Interdisciplinary Science Building

SECOND FLOOR PLAN
MOTORIZED WINDOW
SHADES

PROJECT: 15051-Webster University Interdisciplinary Science Building

RE: Motorized Roller Window Shades Shop
Drawings

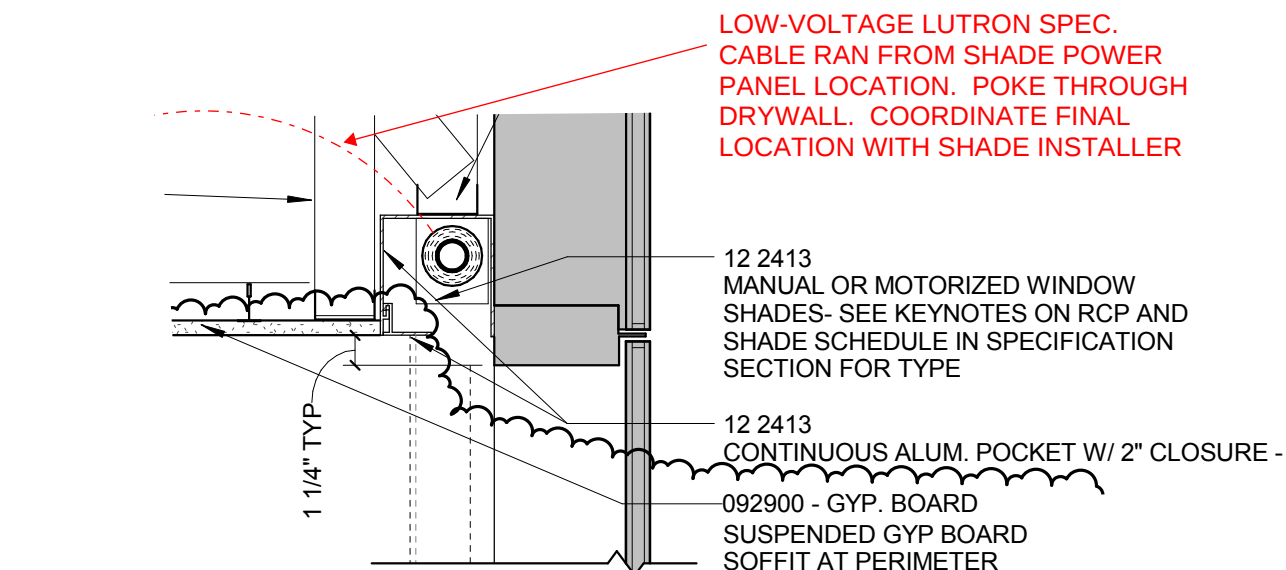
EXTEND SHADE AND POCKET TO CENTER LINE OF MULLION - FACE OF MULLION TO EDGE OF COLUMN COVER SHOULD BE 5 1/2"

CM COORDINATE ROUTING OF CABLE AND LOCATION OF SHADE WITH CURRENT FRAMING

PROJECTED WINDOW SHADE - EAST SIDE

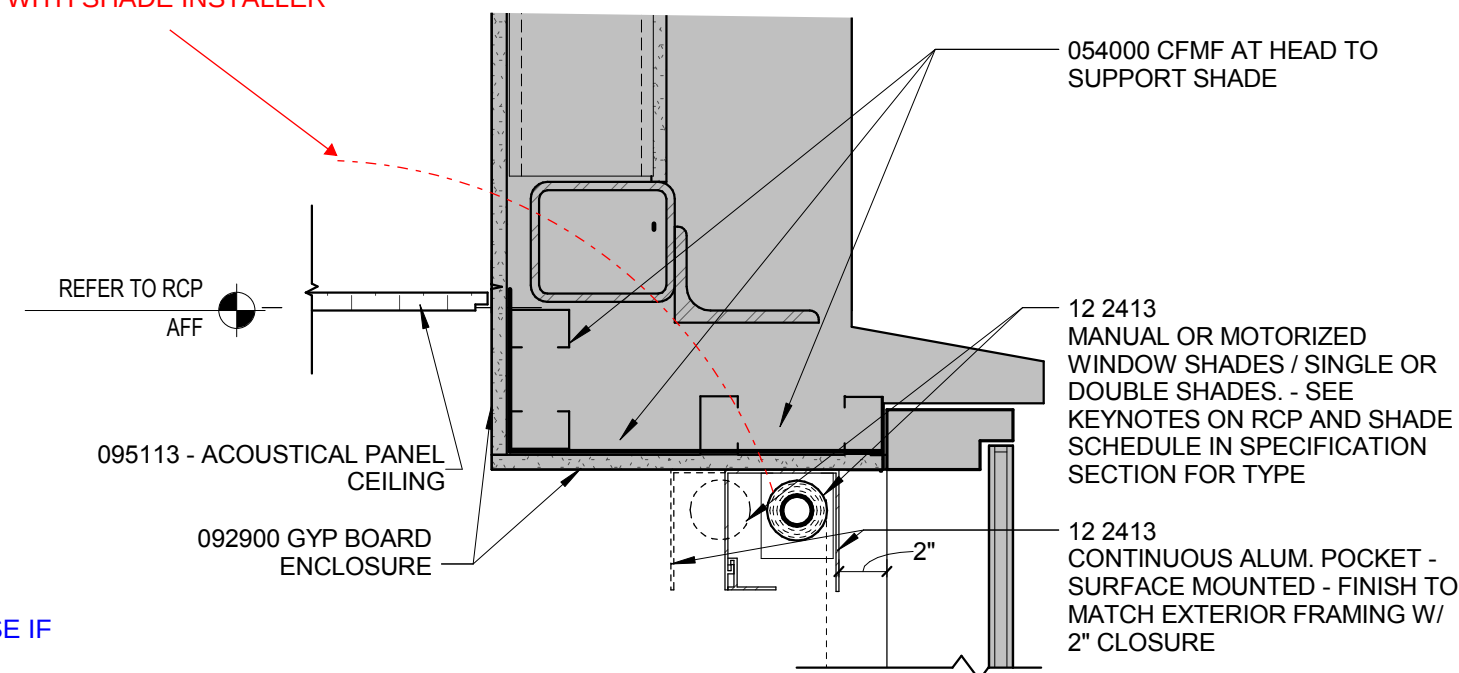
LOW-VOLTAGE LUTRON SPEC. CABLE RAN FROM SHADE POWER PANEL LOCATION. POKE THROUGH DRYWALL. COORDINATE FINAL LOCATION WITH SHADE INSTALLER

RECESSED SHADE - EAST SIDE

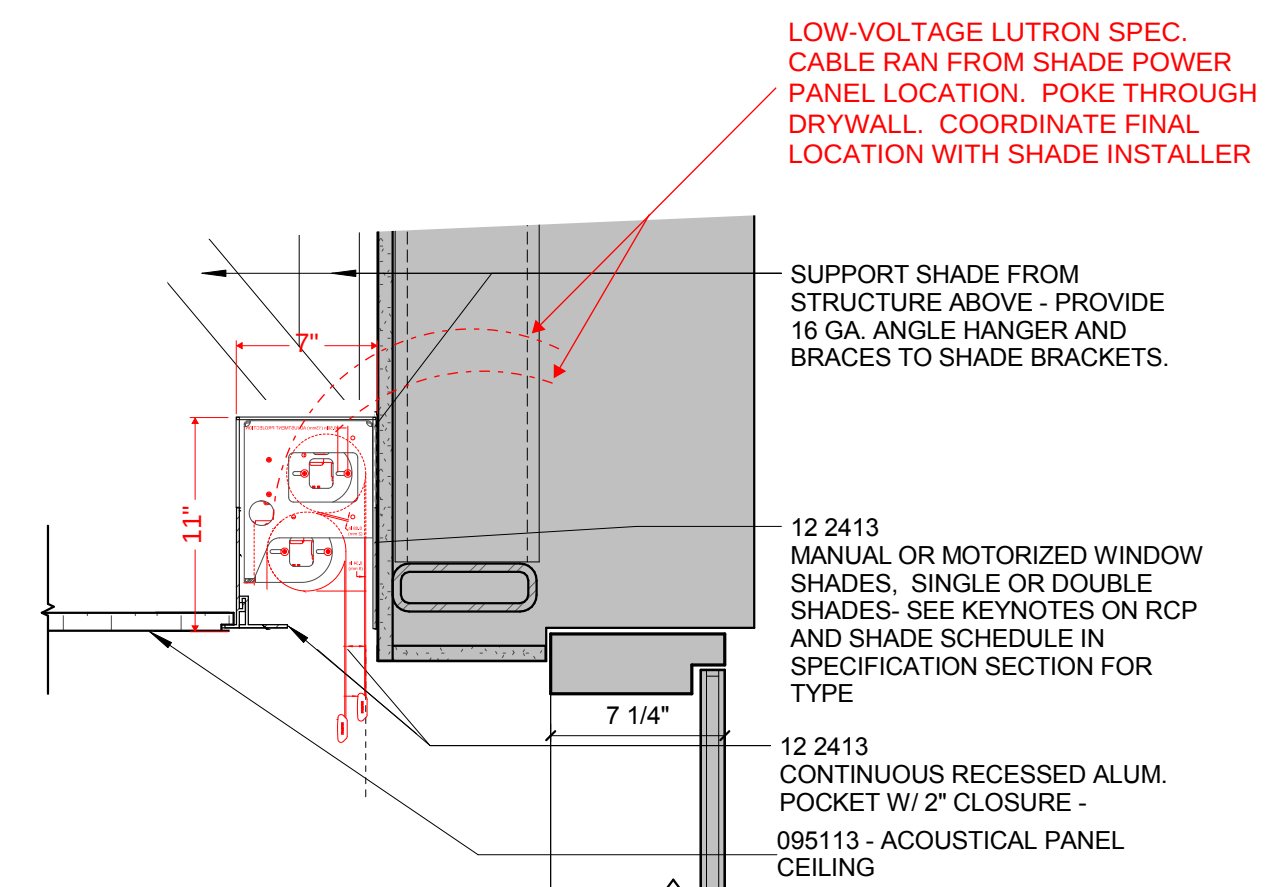
PROVIDE DETAIL WITH DOUBLE SHADE IN CONTINUOUS POCKET PER DETAILS

1 A0841 1 1/2\"/>

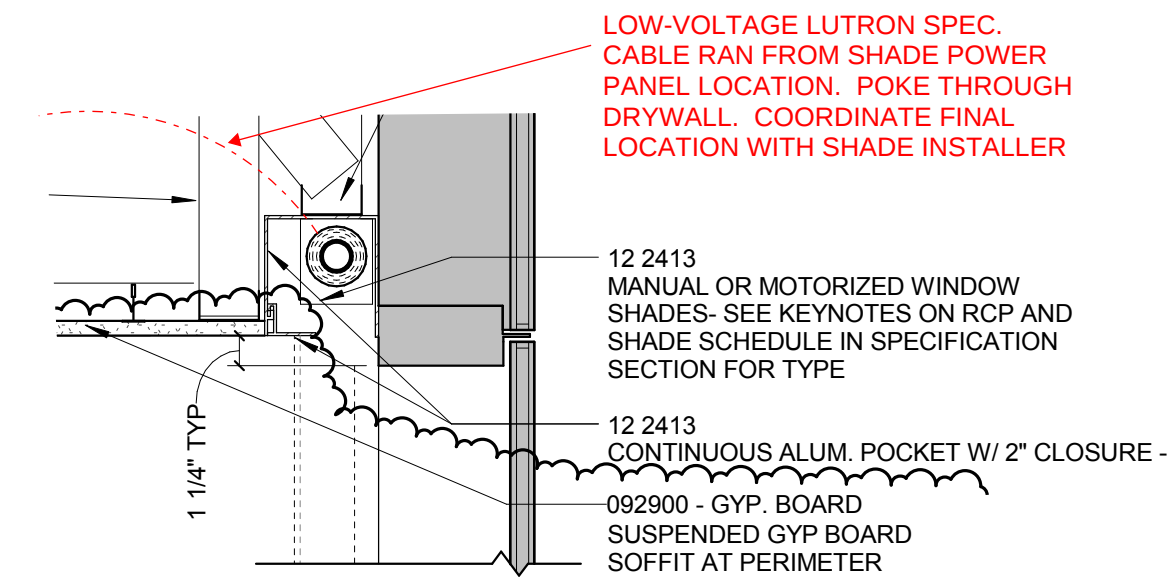
EXTEND SHADE AND POCKET TO CENTER LINE OF MULLION - FACE OF MULLION TO EDGE OF COLUMN COVER SHOULD BE 5 1/2"

CM COORDINATE ROUTING OF CABLE WITH CURRENT FRAMING

4 A0842 1 1/2\"/>

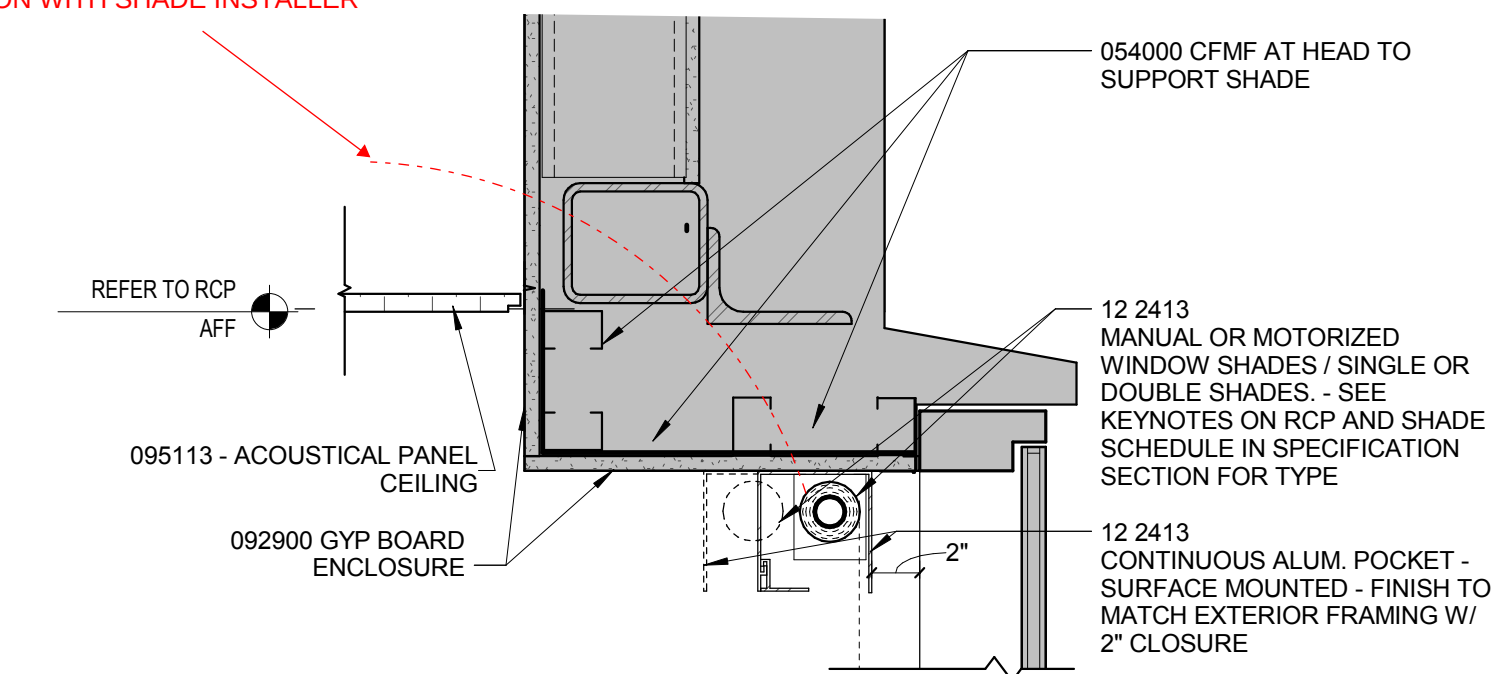
CM COORDINATE ROUTING OF CABLE AND LOCATION OF SHADE WITH CURRENT FRAMING
